Form 3160-5 (August 2007)

SUNDRY NOTICES AND REPORTS ON WELLS	NMNM037
not use this form for proposals to drill or to re-enter an	6 If Indian All

OXY USA Inc. - Proposed Avalon Federal #2 API No. 30-015-21491

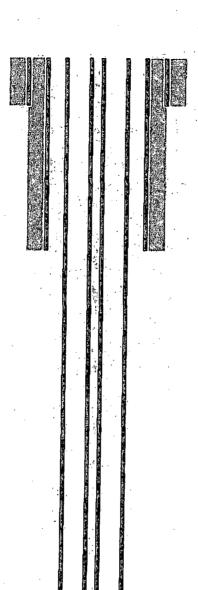
13. Describe Proposed or Completed Ope If the proposal is to deepen directions Attach the Bond under which the wor following completion of the involved testing has been completed. Final Ab determined that the site is ready for fi	ally or recomplete horizontally, given it will be performed or provide the operations. If the operation result bandonment Notices shall be filed or one operation or the control of th	e subsurface locations and measi Bond No. on file with BLM/BIA is in a multiple completion or reco	ured and true ve A. Required sub ompletion in a n	rtical depths of all pertir sequent reports shall be lew interval, a Form 316 i, have been completed,	ent markers and zones. filed within 30 days 0-4 shall be filed once and the operator has	
TD-11700' PBTD-11370' Per	fs-11190-11266' CIBP-1138	30'		NM OIL CO	NSERVATION	
OXY USA Inc. respectfully req	uests to temporarily abando	on this well. It is currently be	eina	ARTESIA	DISTRICT

evaluated for possible future re	ecompletion. Work is currer	ntly planned for the 1st qua	rter 2015.	FEB		
1. RIH & set CIBP @ +/-11140 2. Notify BLM/NMGGB of casi 3. RU pump truck, circulate we	ng integrity test 24hrs in adv	rance. ire test casing to 500# for 0	30 min.		3 2015 IVED	
Above ground steel tanks will I	be utilized.	NMOCD 71 2/5/15		ATTACHED DITIONS OF	FOR

CIBP @ 11140'

- a. A bridge plug or packer must be installed as close to 50 feet above any open perforations or open hole as possible. The bridge plug is to be capped with 35 feet of cement (if bailed) or 25 sacks (if placed with tubing). If a cement plug is used, the top of the cement must be verified by tagging.

- b. The wellbore must be filled with corrosion inhibited fluid and pressure tested to 500 psi. The casing shall be capable of holding this pressure for at least 30 minutes with a 10% allowable leakoff.

Well Name: Submit Subsequent Report and well bore diagram with all Perforations and CIBP with tops of cement. Well may be approved to be TA for a period of 1 year after successful MIT and subsequent report is submitted.
